Proposed Revisions to a Standard Plans Index

Conta	ct In	formation:	Standard Plans:			
Date: January 14, 2021		ry 14, 2021	Index Number: 700-120			
Originator: Malcolm Tomatani			Sheet Number (s): All Sheets			
Phone: (850) 921-7305			Index Title: Enhanced Highway Signing Assemblies			
Email:	malc	olm.tomatani@dot.state.fl.us				
Sumn	nary	of the changes:				
All S	heets	: Re-numbered.				
Shee		Peleted the ground wire from the FRONT VIEW i	n the POWER CONFIGURATON 'B' - WITHOUT AUXILIARY			
Shee	et 2: C	Deleted the ground wire and strain relief fitting from DETAIL "B".				
Shee		Change "Point to Point Microwave" to "Wireless Remove "Microwave" from the FRONT VIEW an				
Shee	et 10:	Renumbered Sheet 11.				
New	/ Shee	et 10 - New sheet for Roadside Sign Assembly-8,	Blank Out Signs.			
Comn	nenta	ary / Background:				
See	e addit	cional sheet.				
Other	r Affe	ected Offices / Documents: (Provide name o	f person contacted)			
Yes	No					
Ц		Other Standard Plans –

Index Number: 700-120

Index Title: Enhanced Highway Signing Assemblies

CONVENTIONALLY-POWERED (Type A1 Shown)

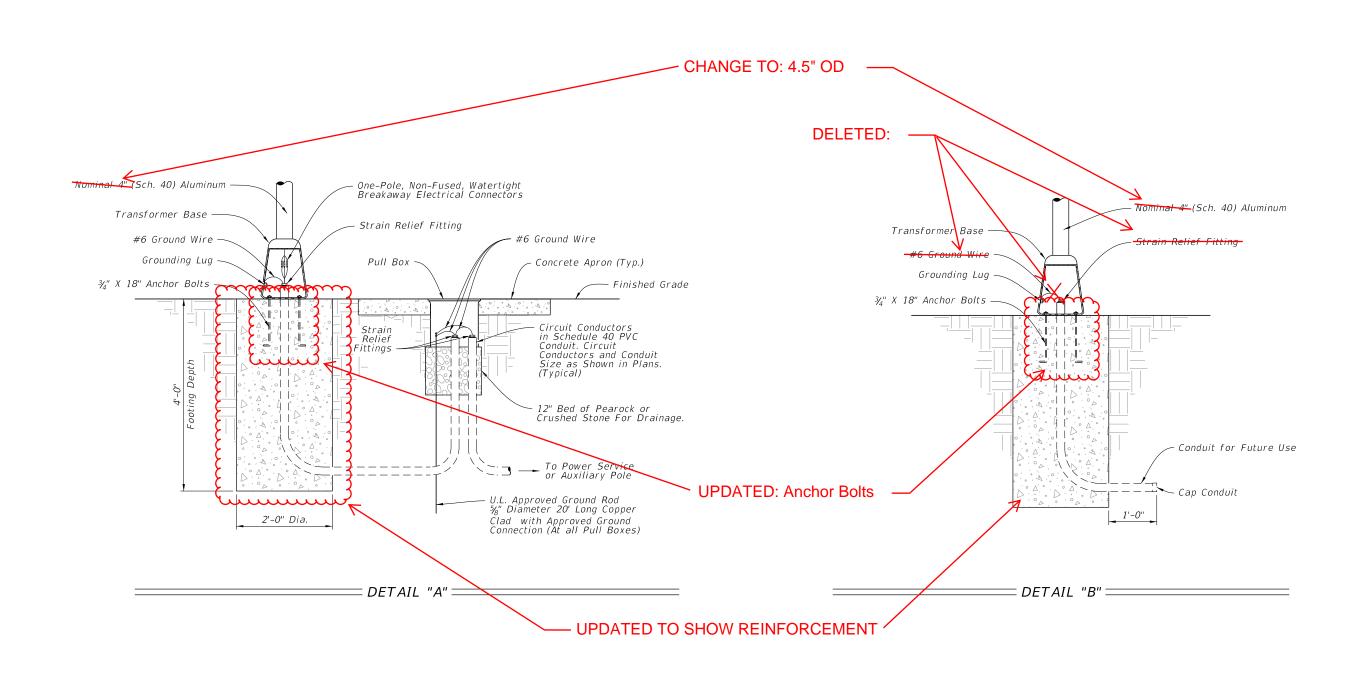
Sheet 1: Updated General Note 4; Change all references "4" Nominal Aluminum Pole" to "4.5" OD Aluminum Pole; Updated anchor bolts.

CONDUIT, WIRING, AND FOUNDATION DETAILS

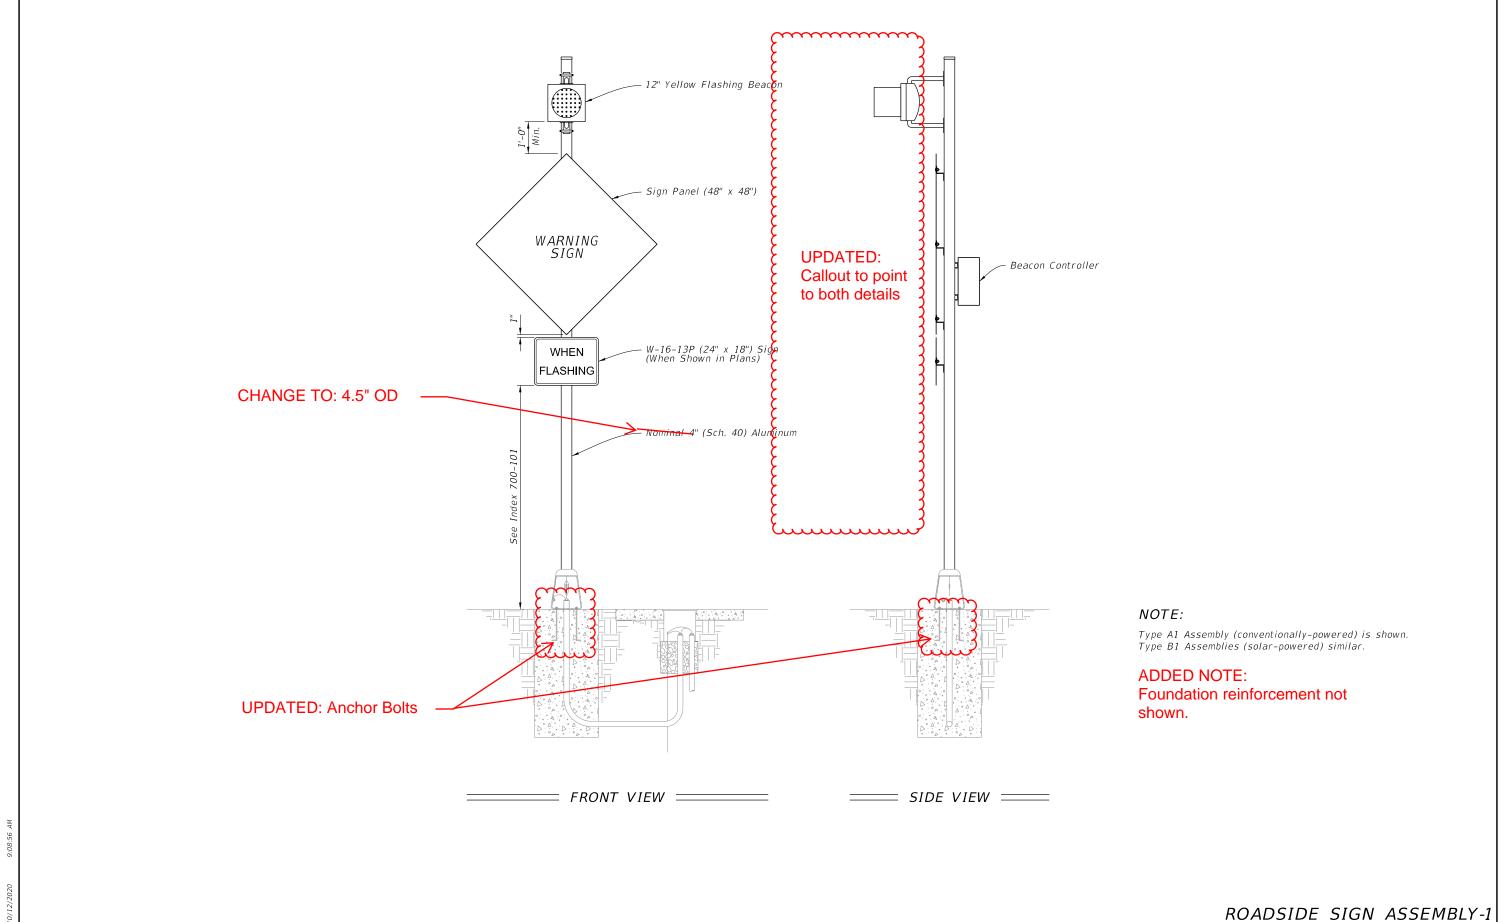
Sheet 2 - A ground wire is not required for a sign assembly without an auxiliary pole. The ground wire will be removed from Detail B on Sheet 2.

Sheet 2: Add new detail to show foundation reinforcement; Change all references "4" Nominal Aluminum Pole" to "4.5" OD Aluminum Pole; Updated anchor bolts.

ROADSIDE SIGN ASSEMBLY-3

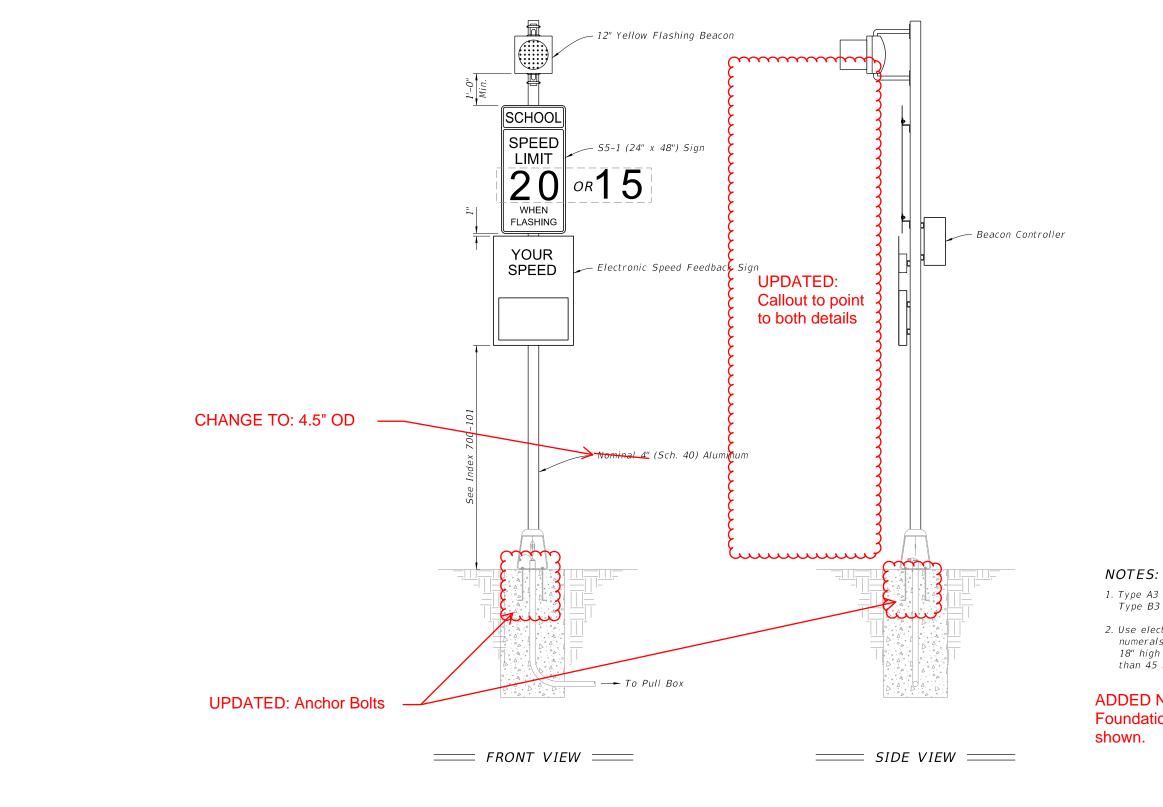
Sheets 3 through 11: Updated callouts to point to both details; Change all references "4" Nominal Aluminum Pole" to "4.5" OD Aluminum Pole; Updated anchor bolts; Added Note "Foundation reinforcement not shown".

ADDED NOTE: Foundation reinforcement not

ROADSIDE SIGN ASSEMBLY-7

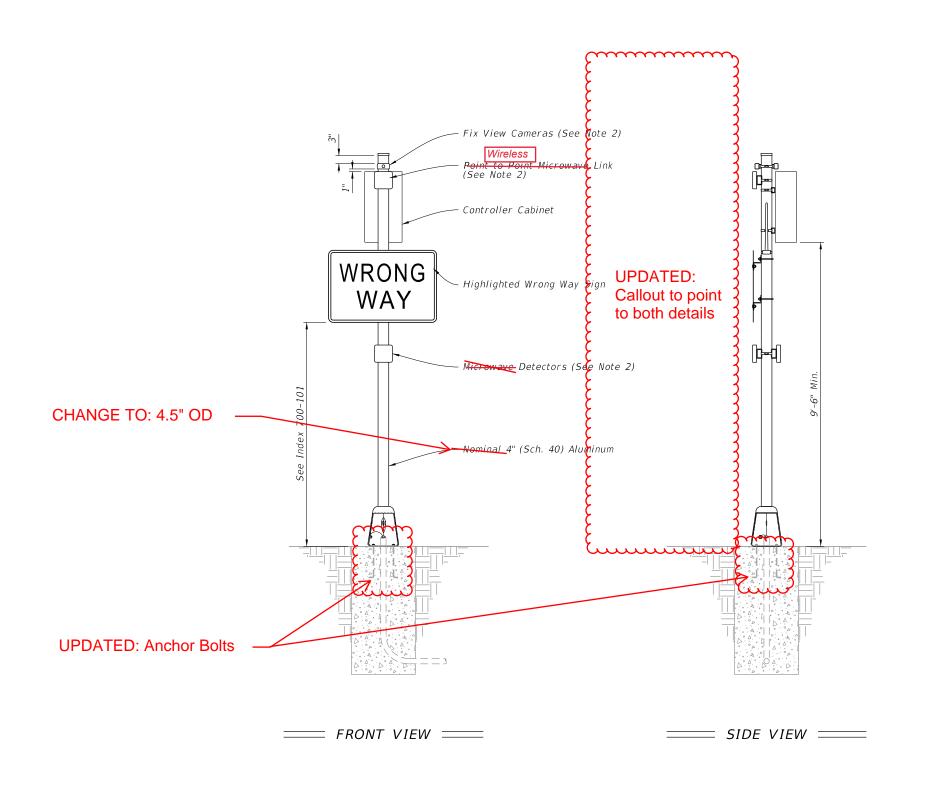
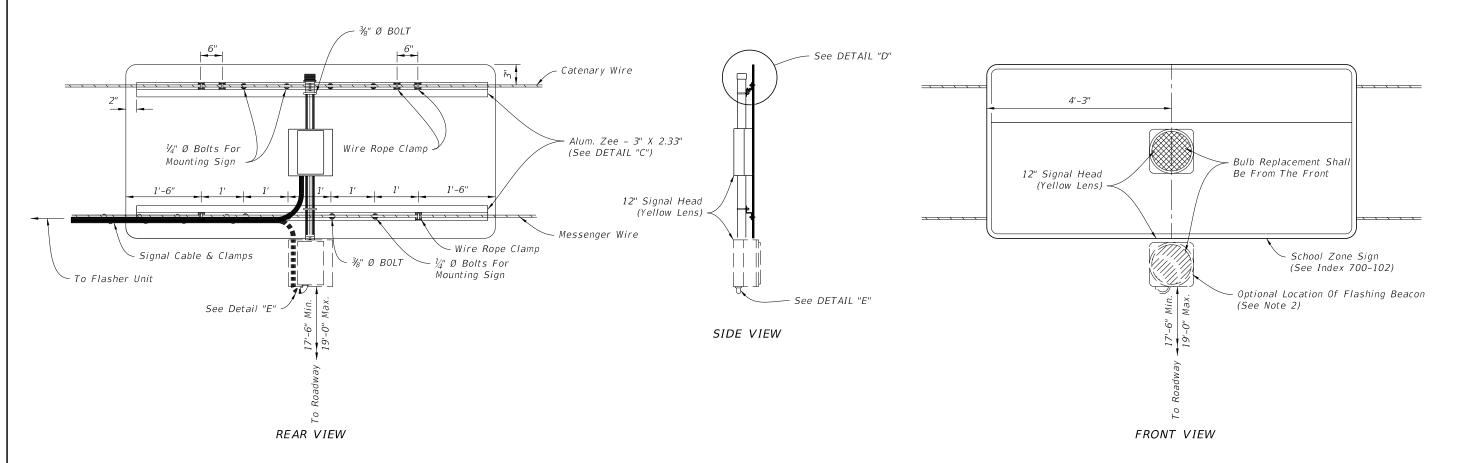
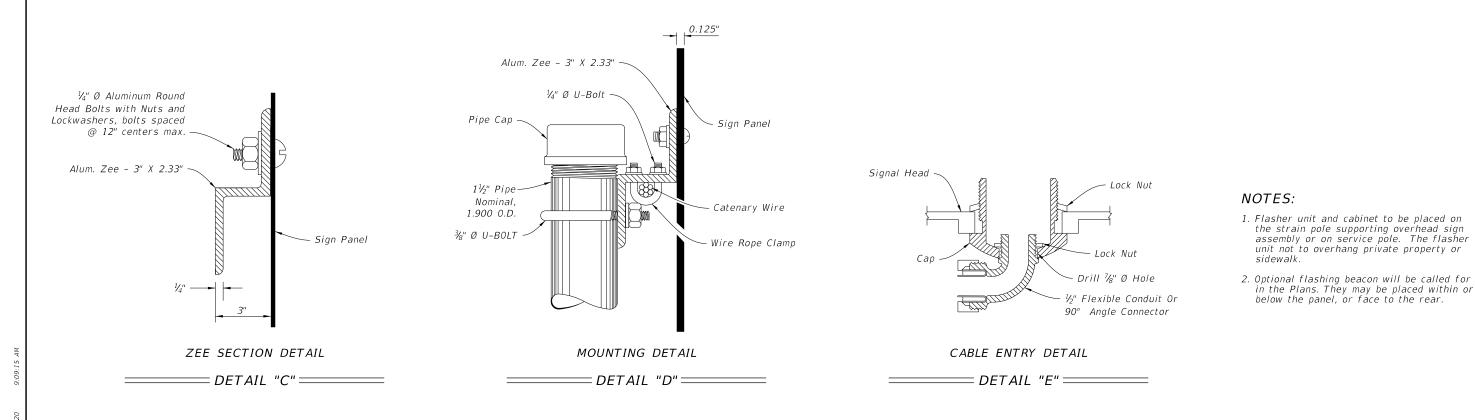
Sheet 9 - The manufacturers have been using omnipolar wireless links between assemblies instead of point-to-point microwave links. Agencies have been using other forms of detection instead of microwave. The Wrong Way Vehicle Detection System detectors shall be nonspecific.

ADDED NOTE:

Foundation reinforcement not shown.

FY 2022-23 STANDARD PLANS ROADSIDE SIGN ASSEMBLY-8

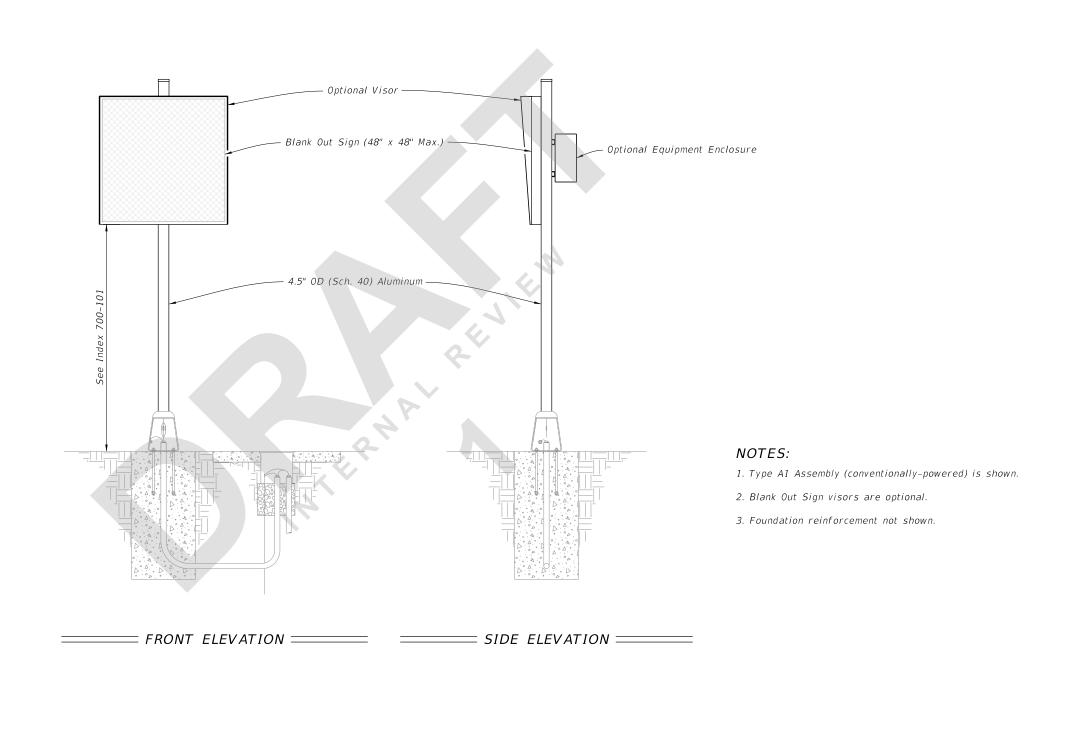
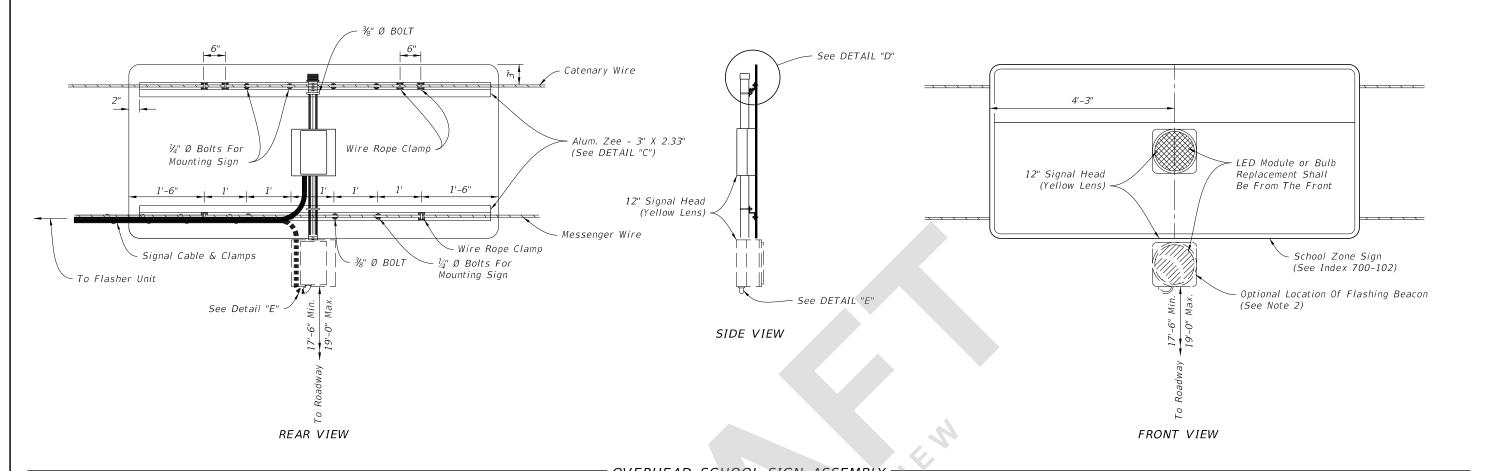
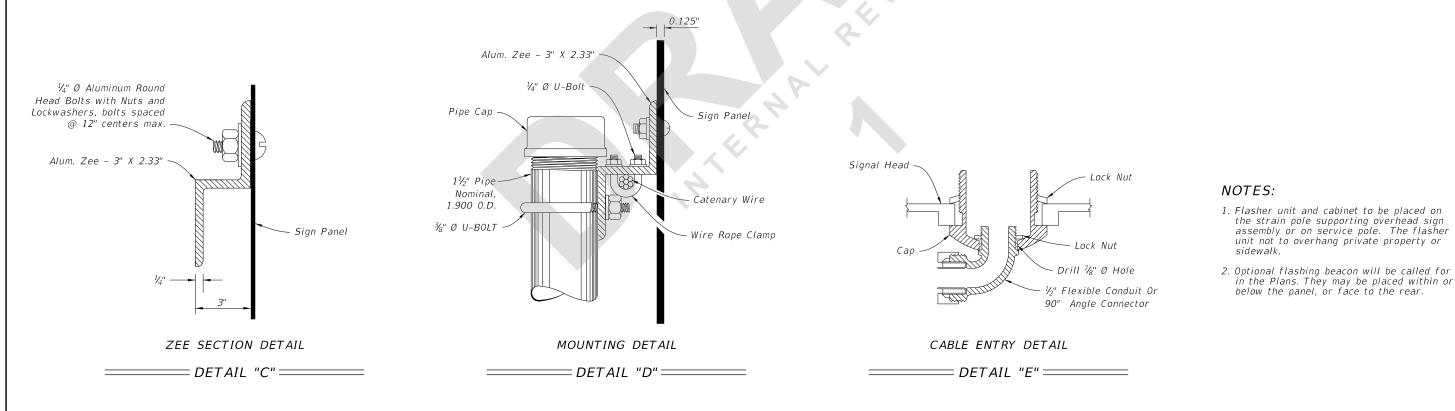
New Sheet 11 - Traditionally, Blank Out signs have been installed on traffic signal mast arms. To allow flexibility in installation, the roadside mounting option is being proposed.
